66103A-07A

S E R V I C E N O T E

66103A DC Power Supply

The instrument will not communicate or will not complete self test.

Diagram A: ROM not fully inserted

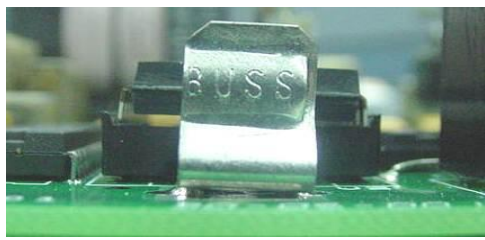
When the ROM “U2” is not inserted correctly See Diagram “A” for details, the instrument may exhibit the following faults:

These faults could also occur if the ROM or the socket is intermittent due to dirty or contaminated pins.

1. The instrument will not turn on
2. All of the segments on the Front Panel display are not light.
3. The instrument will fail self test or will not boot-up.
4. The instrument will not communicate & can not be calibrated.

The ROM “U2” should be removed from the socket. (See Figure 1). The socket and the ROM should be inspected for contamination or other defects. The ROM is a ceramic part and can be damaged or broken if too much force is applied when reinstalled. Diagram “B” shows the ROM “U2” inserted correctly.
